CHART STANDARDIZATION & PAPER CHART WORKING GROUP (CSPCWG)

CSPCWG Letter: 01/2012

Subject: Actions arising from 7th CSPCWG (2010) meeting (Group 2)

Annex A Consolidated responses to CSPCWG Letter 07/2011 (with comments)
Annex B Final text to be submitted to IHO Member States

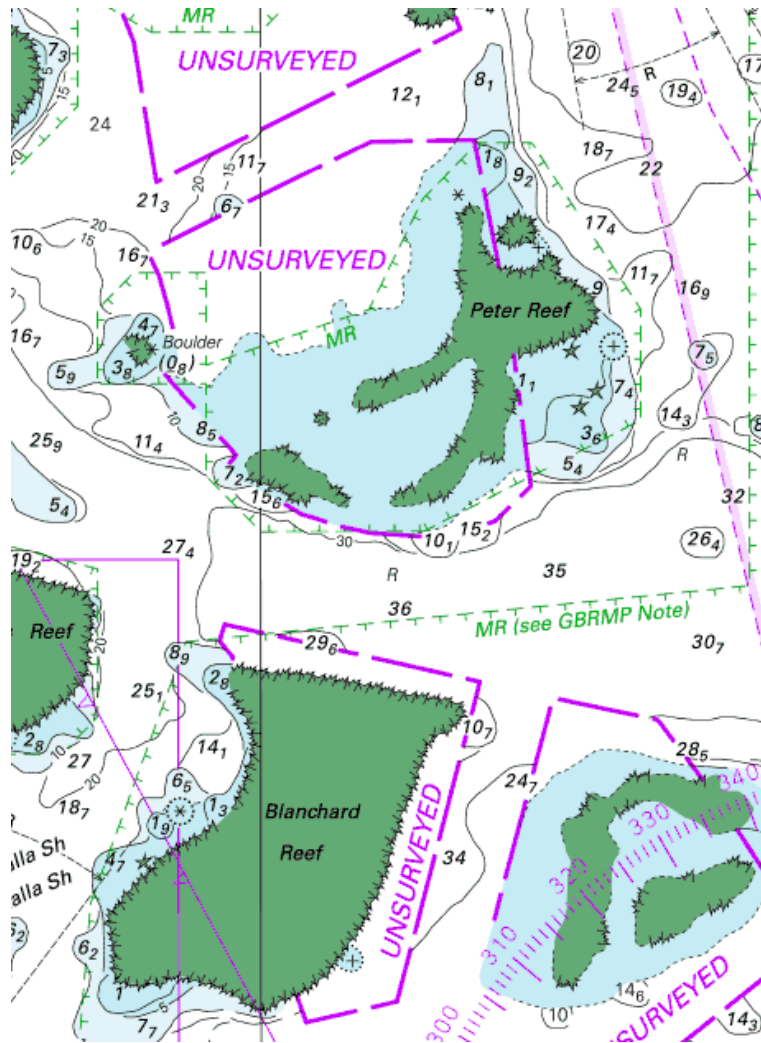
AU agrees that example graphics (as has been used for bridge supports and bathymetry under bridges) is a good idea, particularly in the case of using a bracketed depth adjacent to the berthing facility, as is explicitly mentioned in B-412.2. Note that there is currently no example of the bracketed depth adjacent to a berthing facility in S-4 or INT1, even though it is specified in S-4 at B-412.2.

Action 18: Clause B-424.7: The example included in the new Specification is for possible shoal areas in generally deeper water. At CSPCWG7 AU presented examples of “areas considered to be coral reefs” and “areas of possible shoaling” as sourced from rectified satellite imagery colour banded by depth in the Great Barrier Reef. This imagery identified intertidal areas and areas to depths up to 10 metres in very clear water, shelving off rapidly to depths up to 30 metres as is typically found in the Reef. These areas could be very well defined and as such symbology specifically aimed at depicting these areas was developed by AU in order to indicate the approximate nature of the source, but also the well defined limits as indicated by pecked lines bounding the areas (for intertidal areas such pecked lines are interspersed with short section of coral reef edge symbology to indicate the probable edge of the drying coral reef). Note that AU only uses such imagery in unsurveyed areas. See example (with related explanatory note) below.

REEF AND SHOAL DELIMITATION
 Where the limit of reefs and shoals have not been surveyed, the limit may have been determined from another source. These delimitations are not conclusive and dangers may exist outside the charted limits. Features considered to be reef and shoal areas are depicted by national symbology. See Australian Notice to Mariners No 37 and Australian Seafarers Handbook AHP 20.

AU has no fundamental objection to the new draft Specification, as all the guidance is “should”, therefore variations may be used. But perhaps consideration should also be given for remotely sensed data where the shoal areas are perhaps not so “imprecise”, and a more accurate indication of the position of shoals can be determined from sources such as satellite imagery.

Chairman: An example is shown in S-4 (B-412.2) and INT1 (I11).

Chairman: We have included this example as a further option.

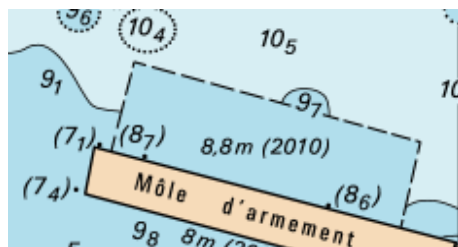
Action 12: The reference to very large scale chart should be illustrated, if necessary, by the terms given in B-126 (e.g. Berthing charts).

One example to illustrate “If the scale is too small to show the dredged limit parallel with the berth, it is still possible to show some ‘out of position’ soundings alongside, in parentheses either within the dredged area or on the adjacent land, as explained in B-412.2; see also B-414.5.”

Chairman: We will amend to ‘If the chart scale is sufficiently large, it may be possible...’

Chairman: Thank you, the graphic is a useful example and will be included. It is the only example we have received.

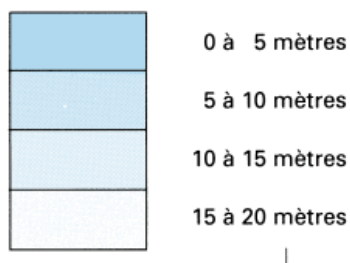
Action 18: The specifications should include also the possibilities of having more precision for the depiction of the depths of shoals, particularly at large scales, depending of the tools and methods used.

See French notes for such application:

Translation: In the zones where the bathymetric data come from the interpretation of the data of the satellite SPOT, the nuances of blue correspond roughly to the following depths:

Important warning: to mitigate an absence of data resulting from traditional surveys outside of the magenta limits, bathymetric and topographic information resulting from the interpretation by the SHOM of the data of the satellite SPOT were illustrated on this chart. These informations appear in blue and buff. The attention of the navigator is drawn to their indicative character and the precaution with which they must be used. Thus the real depths can be appreciably lower than those suggested, and it can exist nondetectable shallow waters in teledetection.

Chairman: I think 'more precision' is covered by AU's suggestion, see above and the additional option which will be included.

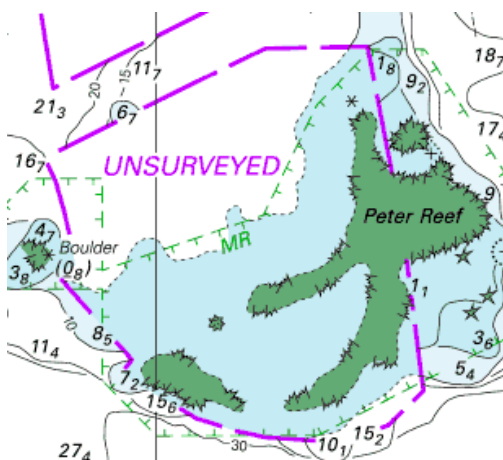
Action 18: The proposed B-424.7 contradicts B-417.6 and B-418.1 which state that ‘Such areas must be shown by bold dashed black or magenta limits...’. We propose that the blue area shown in the graphic be delimited by ‘bold dashed black or magenta limits’ and the legend in B-417.6 or B-418.1 be added. The proposed Shoal Areas note could be reworded to become an Inadequately Surveyed or Unsurveyed note, with a reference to the dashed limit rather than the lack of contours.

Chairman: These are methods of depicting some limited information within larger areas that are poorly surveyed or unsurveyed. Adding the bold dashed limiting line in these circumstances would be misleading, as it would imply that the other side of the line is surveyed. For placement in S-4, see comment at AU above.
